647.0111
Job Sheet 168273

APICAL INDUSTRIES, INC.	ENGINEERING CHANGE NOTICE NO. 03985			SHEET 1 OF 2	
	DWG NO. 647.0100	REV: A	PREPARED BY J. BECKER	DATE: 7/15/13	EFFECT ON DWG ☐ INC. ☒ UNINC.
	DWG TITLE: SHEET METAL				
	APPROVED BY: ENGR 	MFG 	QC 	EFF. NEXT ORDER	
TRANSACTION CODES (TC): A-ADD R-REVISE	REASON: REVISED NOTE 2. ADDED 647.0117				
C-CREATE D-DELETE

QTY	FIND #	PART #	DESCRIPTION	MATL	SPEC.
		647.0116	DOUBLER	△	△
		647.0115	CLIP	△	△
		647.0114	CLIP	△	△
		647.0113	STRUT DOUBLER	△	△
		647.0112	STRUT BRACKET	△	△
		647.0111	PANEL	△	△
		647.0110	ROOF DOUBLER	△	△
PARTS LIST			APICAL INDUSTRIES		
NEXT ASSY (S)			2608 TEMPLE HEIGHTS DR.		
646.9500			OCEANSIDE, CA. 92056-3512 (760)724-5300		
			SHEETMETAL		
			647.0100		
			SCALE NONE		
			SHEET 1 OF 6

SHEET 1, ZONE D1 IS:

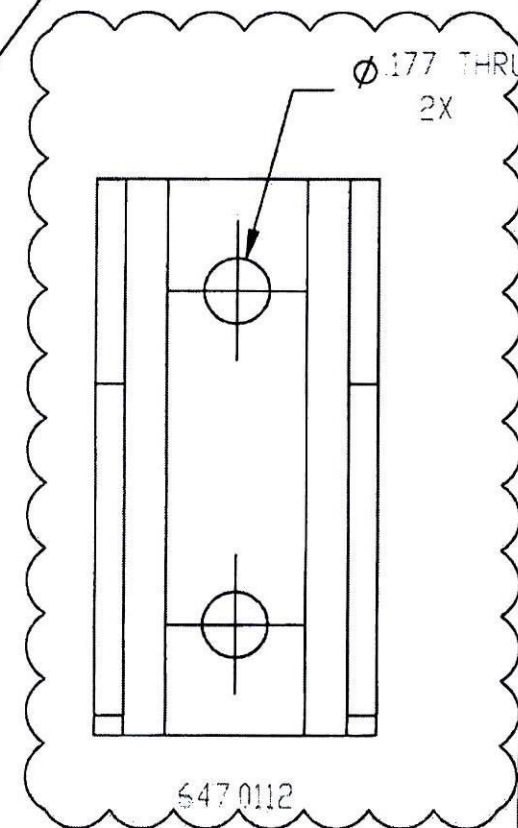
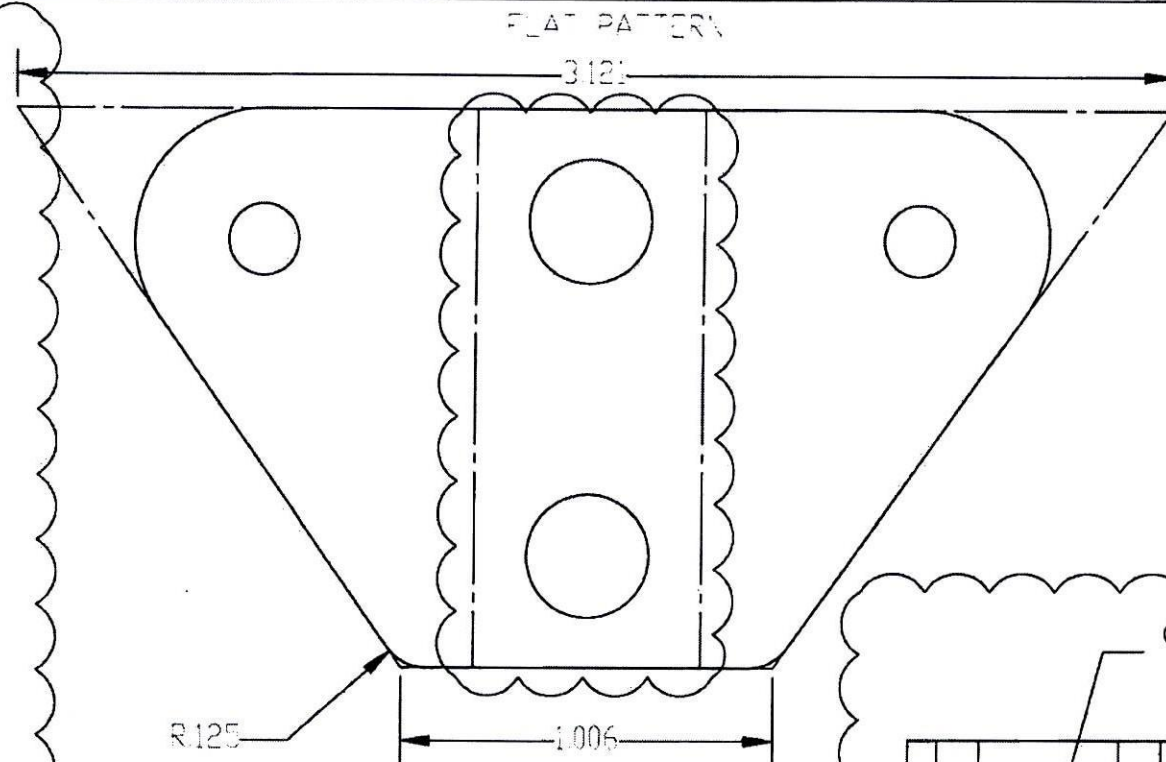
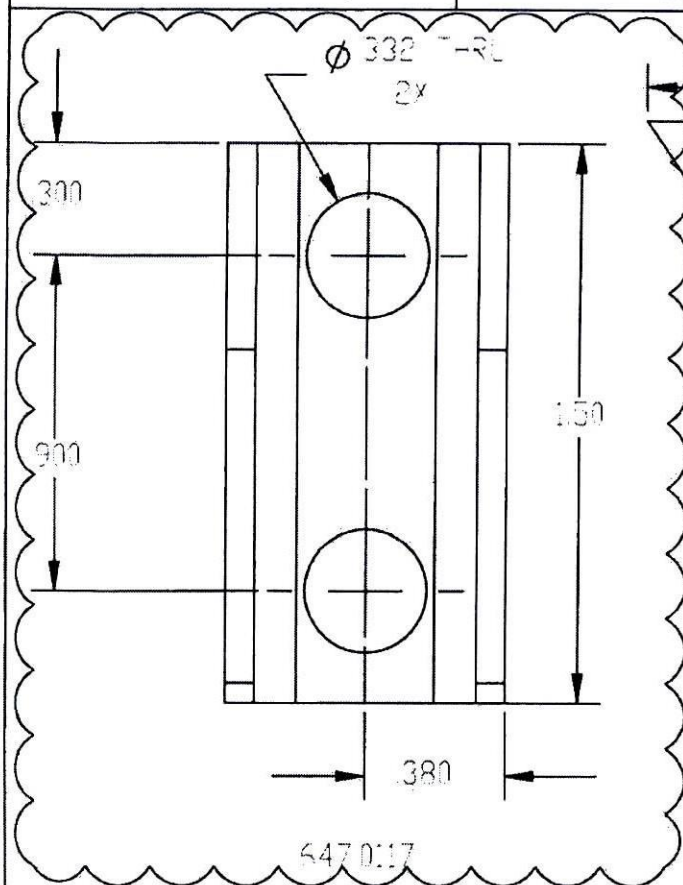
- 1 MATERIAL: ALUMINUM 2024-T3 PER AMS-QQ-A-250/4.
- 2 FINISH: IAW MPP-172 ANODIZE IAW SECTION 2.1,
PRETREATMENT IAW SECTION 3.1
AND PRIMER IAW SECTION 4.1.
3. DEBURR AND BREAK ALL SHARP EDGES.
4. IDENTIFY IAW MPP-120.
- 5 MATERIAL: 304 SS IAW AMS 5643.
- 6 FINISH: PRIME IAW MIL-P-23377J TYPE I CLASS N.
- 7 OTHER DIMENSIONS SAME AS 647.0112.

C	647.0117	STRUT BRACKET		△	△
F/N TC	PART NUMBER	DESCRIPTION		MATERIAL	SPECIFICATION
DOCUMENTS EFFECTED:		CHANGE CATEGORY		DER REVIEW REQUIRED	
☐ MDL ☐ INSTALL INSTRUCTIONS ☐ ICA ☐ FMS ☐ BOM		☐ MAJOR ☒ MINOR		☐ YES ☒ NO
